STAFF RECOMMENDATION
1608 Holly Street
June 18, 2014

Application: New construction-addition
District: Lockeland Springs-East End Neighborhood Conservation Zoning Overlay
Council District: 06
Map and Parcel Number: 0831403000
Applicant: Craig Kennedy
Project Lead: Paul Hoffman, paul.hoffman@nashville.gov

<p>Description of Project: This application is for a rear addition and screened porch to this contributing home.</p> <p>Recommendation Summary: Staff recommends approval of the application with the conditions:</p> <ul style="list-style-type: none"> • That Staff review roofing color, windows and doors prior to their purchase and installation; and • The screened porch shall have a one foot (1') inset for a depth of at least two feet (2'). <p>Meeting these conditions, Staff finds that the project meets section II.B of the Design Guidelines for the Lockeland Springs-East End Neighborhood Conservation Overlay.</p>	<p>Attachments A: Photographs B: Site Plan C: Elevations</p>
-----------------------------------------------------------------------------------------------------------------------------------------------------------------------------------------------------------------------

FLOOR PLAN

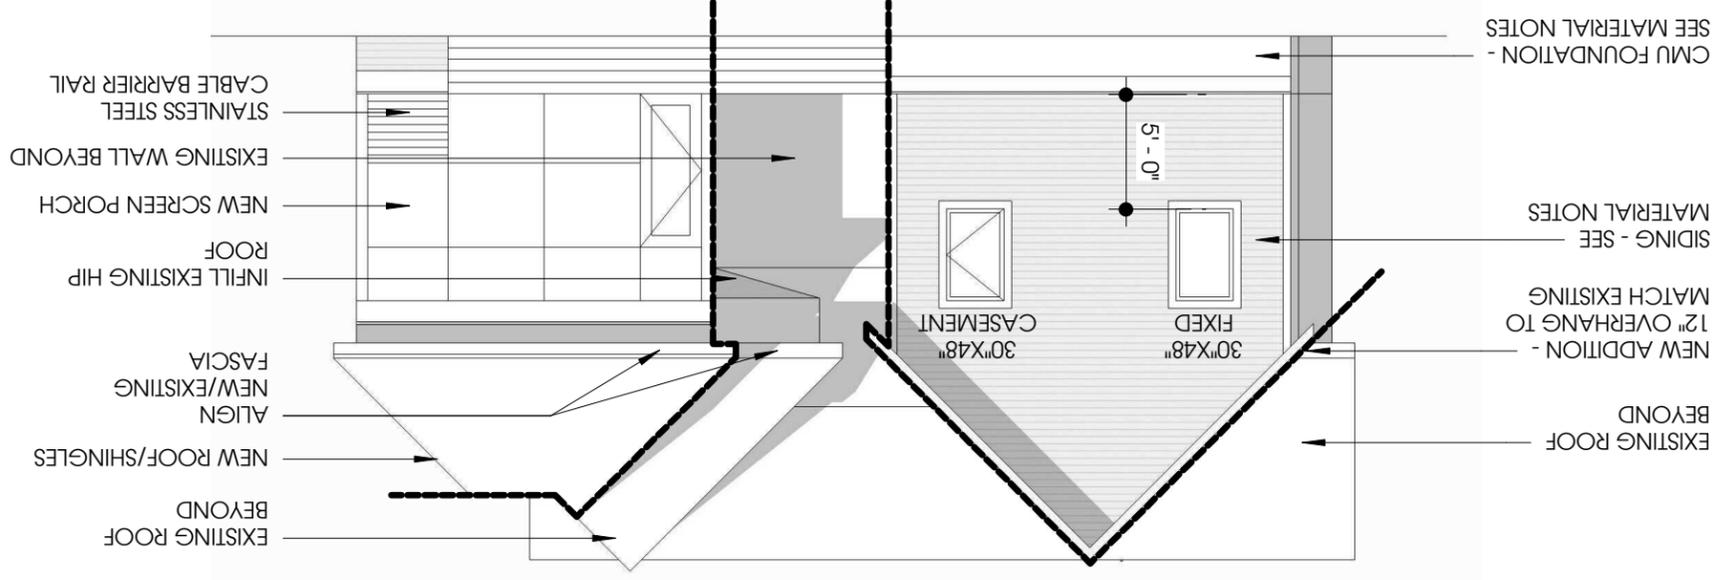
Location & Removability: The addition and screened porch will be at the rear of the house. The plans submitted do not indicate an inset for the screened porch. The applicant has agreed to set in this portion one foot (1') for at least two feet (2') back, in accordance with design guidelines, before it widens to approximately four feet (4') past the side of the house. The design guidelines state that a rear addition that is wider than an existing historic building may be appropriate when the building is shifted to one side of the lot, which is the case here. With the condition that the screened porch shall have a one foot (1') inset for a depth of at least two feet (2'), the project meets section II.B.2 and 10.

Setback & Rhythm of Spacing: The project meets all base zoning setbacks. Although the screened porch extends past the left rear corner of the house, Staff finds it to be acceptable with the requested inset. It will be approximately ten feet (10') from the side property line, meeting setback requirements. The project meets section II.B.3.

- That Staff review roofing color, windows and doors prior to their purchase and installation; and
- The screened porch shall have a one foot (1') inset for a depth of at least two feet (2').
